# ATTACHMENT 1

# **REVISED PROPOSED CATAWBA TECHNICAL SPECIFICATIONS CHANGES**

3/4.8.2 D.C. SOURCES

REVISED JUSTIFICATION AND SAFETY ANALYSIS

Figure 1 depicts the DC portion of the vital I&C power system.

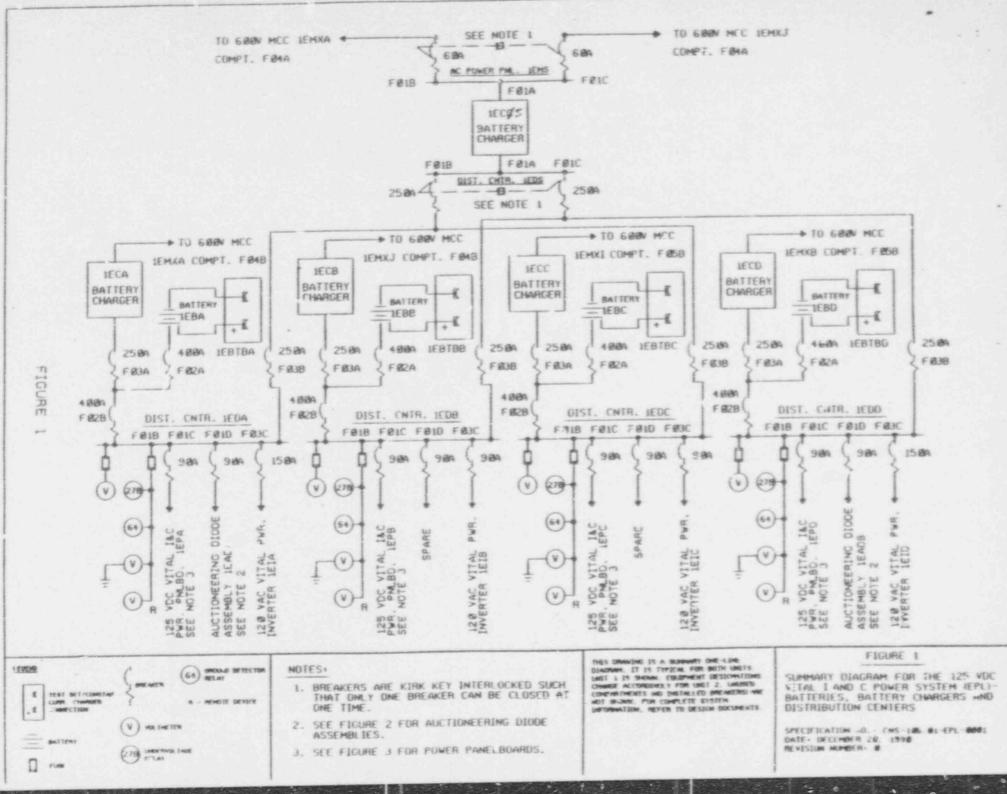
Because of the design of the DC portion of the vital I&C power system at Catawba, deleting the shutdown requirement from Surveillance Requirement 4.8.2.1.1.d will have no significant effect upon nuclear safety. Due to Catawba's ability to cross-tie a vital bus to an alternate battery as indicated in the above discussion and as illustrated in Figure 1, the affected channel will remain battery-backed while its battery is taken out of service in order to perform the service test. When a service test is being performed on a particular battery, the associated battery charger is removed from service and the standby charger (ECS) is connected to the affected distribution center. Therefore, both a battery and two battery chargers remain available to supply the cross-tied channels during the test.

It should be noted that one of the findings of the Catawba EDSFI involved whether calculations support that a s. all battery (825 ampere-hour) could adequately supply two channels in a cross-tied configuration while a large battery (1200 ampere-hour) is out of service. During the EDSFI audit, there was not sufficient time to resolve the concern by updating the analytical model or correlating test results in detail.

The 825 ampere-hour battery calculations reviewed during the EDSFI are overly conservative because: 1) only two periods were established for the one-hour duty cycle (first minute = 1st period; last 59 minutes = 2nd period); 2) both non-continuous and momentary loads are assumed to be continuous for each respective period of the duty cycle; and .) loads were conservatively estimated. Following the EDSFI, Duke Power Company has been in the process of revising this calculation. Although the revision has not been finalized, preliminary assessments have identified specific conservatisms and demonstrate that the loads for the two channel cross-tied configuration are below the 825 ampere-hour battery capacity. Table 1 details these specific load revisions, the respective bases for the load revision, and the revised load requirements for each period of the 825 ampere-hour battery duty cycle. Table 2 incorporates the changes listed in Table 1 and details the total loads for two channels being fed from a single 825 ampere-hour battery. Based on Table 2, the adjusted battery discharge current is approximately 316 amperes for the first minute, 200 amperes for the 1-10 minute period, 198.5 amperes for the 19-20 minute period, and 188 amperes for the 20-60 minute period. The corresponding battery terminal end voltages are 112.7 VDC, 115.1 VDC, 114.5 VDC, and 113.3 VDC, respectively.
